Peyton Estates Unit Five

City of El Paso — City Plan Commission — 11/30/2017 SUSU17-00092 — Major Combination

LOCAL RESIDENTIAL (54' RIGHT-OF-WAY)

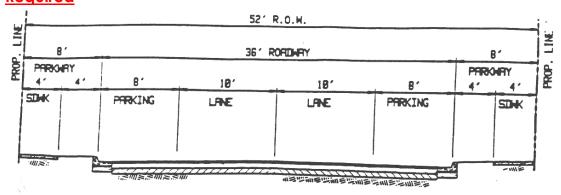
2: A modification from the standard 54-foot wide right-of-way residential subcollector to allow for 5-foot wide sidewalks, 5-foot parkways, and 34 feet of pavement within all the 54-foot wide public right-of –ways within the subdivision.

MARK TWAIN DRIVE (56' RIGHT-OF-WAY)

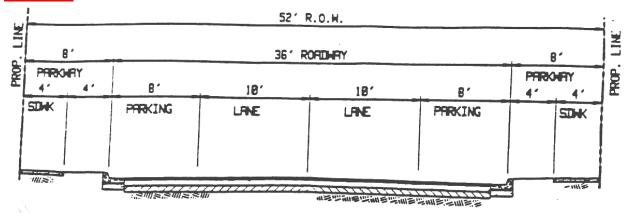
3: A modification from the standard 52-foot wide right of way residential subcollector (Mark Twain Avenue) to an 56-foot wide public right of way to allow for 11 feet of additional right of way, and 30 feet of pavement.

- Currently there is no sidewalk or parkway, and the ROW ends at the curb.
- The Applicant proposes to dedicate an addition 11 feet of ROW as a parkway, but not a sidewalk.
- As part of the subdivision improvement plans for the subdivision, the Applicant proposes to construct a trail that will parallel Mark Twain Drive within the common open space lots that abut Mark Twain Drive.

Staff is concerned with the proposed cross-section for Mark Twain Drive, as it does include a sidewalk. In addition, there is a safety issue at the intersection of Rojas Drive and Peyton Drive, as well as at the intersection of Aberdare Drive and Bretby Place.

- Sight distance issue at the intersection of Aberdare and Bretby Place
- Need additional R.O.W at the intersection of Rojas and Peyton for right only turning lane as you head west on Rojas.
- The County will require sidewalk along Mark Twain

Figure No. 1 Aerial and Plat

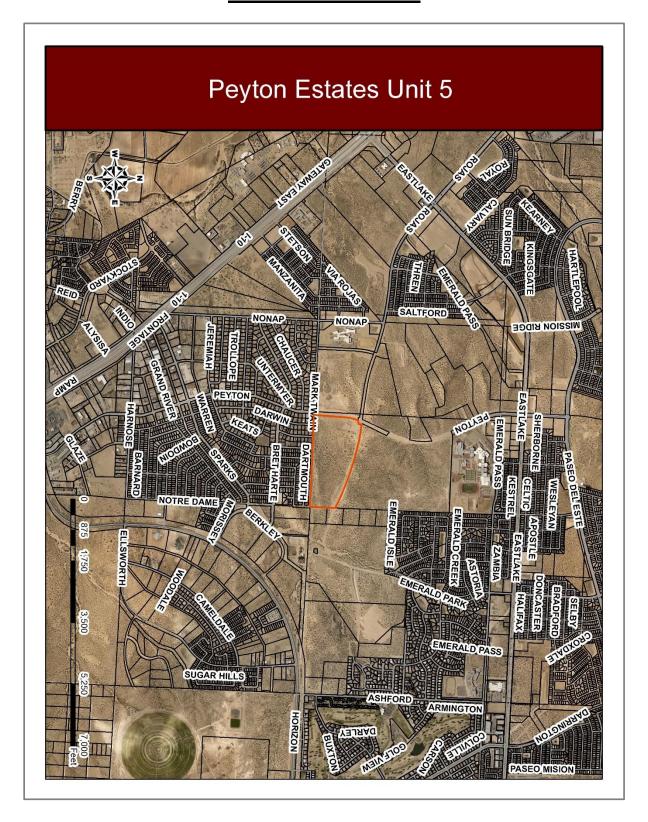
- Additional R.O.W is needed at the intersection of Rojas and Peyton for a right turning lane;
- The Applicant submitted a cross-section of Mark Twain without a sidewalk; and
- There is a sight distance issue at the intersection of Aberdare Drive and Bretby Place.
